**Neighborhood Housing and Community Development Office**

**Date:** June 21, 2006  
**To:** Mayor Will Wynn and City Council Members  
**From:** Paul Hilgers, Director  
Neighborhood Housing and Community Development  
**Subject:** Affordability Impact Statement - Residential Design Ordinance (June 8, 2006 Council Action)

# Attachment: AHFC House Plans for Montopolis Subdivision (sample)

**1202B**

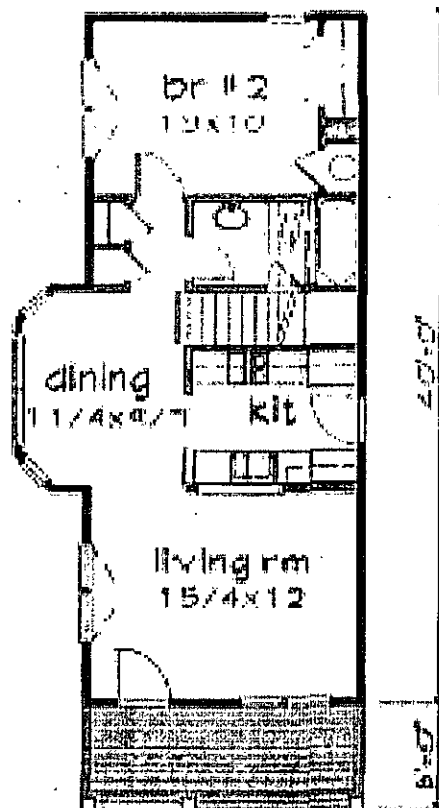
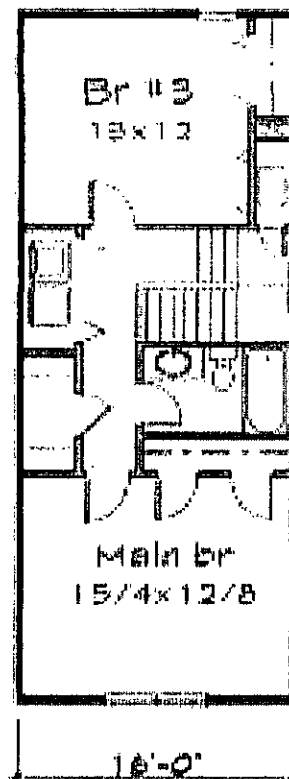
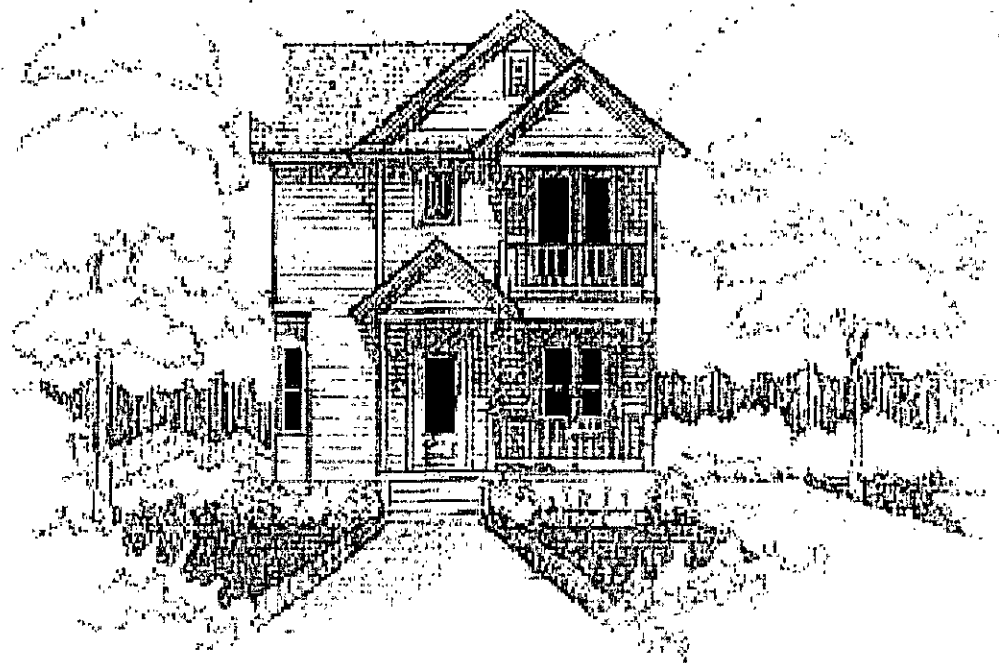
All of the two-story house plans selected for the NHCD/AHFC Montopolis subdivision – some homes as small as 1102 square feet – will not be in compliance with the new ordinance, due to side wall lengths of greater than 32 feet. Redesigning the plans will add

The vast majority of lots in the Montopolis subdivision range from 40 - 45 feet in width and 4500 square feet in area. Most of these lots require a two-story design in order to allow a home large enough for a family while meeting impervious cover limits. Narrow lots also require home designs that yield a longer, more narrow home. The subdivision is zoned SF-3-NP and utilizes the Urban Home Lot provision in the Montopolis Neighborhood Plan. (Please see Attachment: AHFC House Plans for Montopolis Subdivision.)

NHCD's recommendation is to amend the wall articulation requirement § 25-2-566 (I) to apply to allow an unbroken plane of 45 feet.
